Preservice Examination Report
For Replacement Steam Generators

NEWYORK POWER AUTHORITY
INDIAN POINT 3 NUCLEAR POWER PLANT
DOCKET NO. 50-286
DPR-64

**PRESERVICE EXAMINATION REPORT
STEAM GENERATOR REPLACEMENT**

SUBJECT: INDIAN POINT 3 RELIEF REQUEST (TAC 69190)

STEAM OUTLET NOZZLE FORGING
PRIOR TO CLADDING AND
FLOW RESTRICTOR INSTALLATION

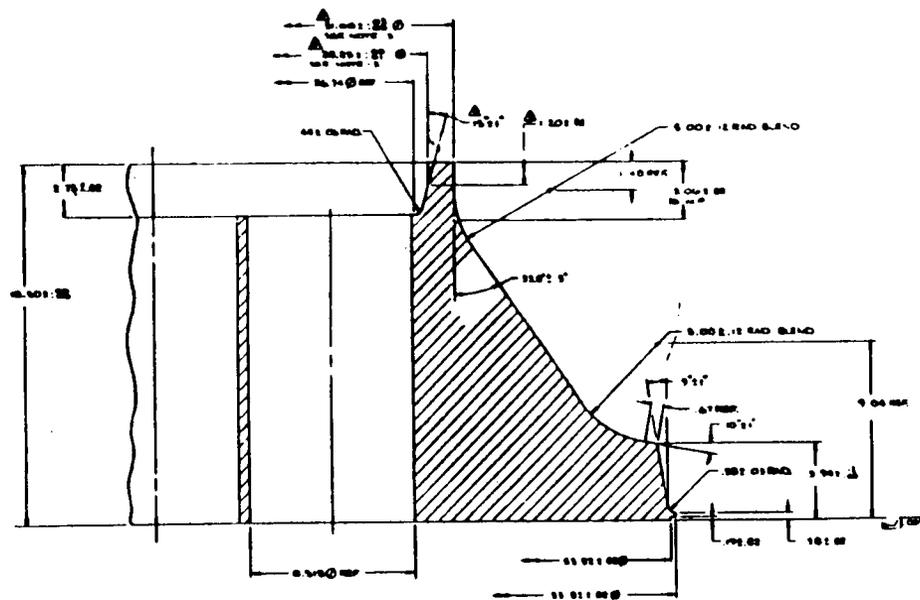
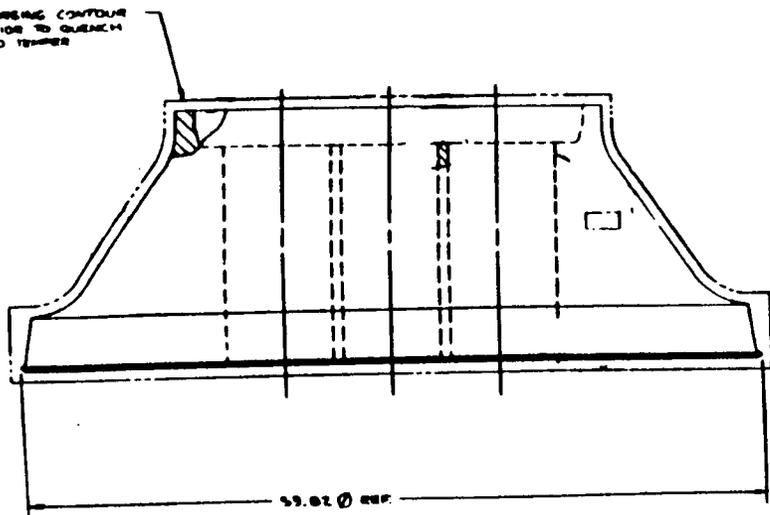
1. COMPONENT: Steam Generators Steam Outlet Nozzle
2. CODE REFERENCE: Asme Boiler and Pressure Vessel Code
Section XI 1983 Edition thru Summer 1983
Addenda IWC-2500-1 Category C-B Item C2.22

3. CODE REQUIRED EXAMINATION: Volumetric Examination of 1 Mainsteam
Nozzle Inside Radius Section (IWC-2500-1
Category C-B Item C2.22)
4. ALTERNATE EXAMINATION: The steam outlet nozzle should be
excluded from the requirements for
reasons outlined below. The nozzle areas
will be examined for evidence of leakage
during Section III shop hydrostatic test
and the subsequent preservice Section XI
hydrostatic test following installation
of the steam generators as required by
ASME Boiler Pressure Vessel Code.

5. BASIS FOR RELIEF REQUEST: The Main Steam Nozzle is welded to the
Steam Generator. Section XI requires
volumetric examination of the inside
radius section of nozzles greater than a
nominal pipe size of 12 inches in Class 2
vessels. In the case of Indian Point No.
3 Steam Generators, due to design, the
Main Steam Nozzles do not have an inner
or blended radius section to examine.
The nozzle is a one piece forging with
seven holes bored parallel to the nozzle
centerline. Inconel flow restrictors are
subsequently installed within each of
these holes and attached to cladding that
is weld deposited onto the bottom surface
of the nozzle. The cladding serves as a
medium of attachment for the inconel flow
restrictors and as an erosion barrier to
protect the nozzle forging. Due to the
Main Steam Nozzle not having an inner
radius blended section to examine, the
Section XI requirements are not
applicable. The I.D. of the Steam Outlet

Nozzle is not accessible for visual
examination due to interference from the
installed steam separator packages on the
inside and the internal geometry of the
nozzle itself precludes access for visual
examination from the outside.

Examinations performed to Section III on the steam outlet nozzle include the following: 100% Ultrasonic inspection of the nozzle forging prior to final machining followed by magnetic particle and visual inspection after final machining. Examinations performed on the weld deposited cladding in the area beneath the bored hole corners include ultrasonic (for bond and defect), liquid penetrant and visual examination. Upon attachment of the flow restrictors the welds are liquid penetrant and visually examined.

A. RELIEF REQUEST - Relief is requested from the volumetric examination requirement for the steam generators steam outlet nozzle inside radiused sections.

The design of the main steam outlet nozzles does not incorporate the blended radiused area between the nozzle wall and vessel shell as incorporated in the design of nozzles for which the Code examination requirements are applicable. (See attached SKETCH)

We have reviewed your relief request for the steam generator nozzle inner radius sections and conclude that relief is not required. The basis for our conclusion is given in the enclosed Safety Evaluation.

The nozzles were designed to contain flow restrictors and were fabricated from forgings with seven holes bored parallel to the nozzle centerline. Since no inside radiused sections exist in the nozzle-to-shell design, the staff finds that relief from the examination requirement is not necessary.
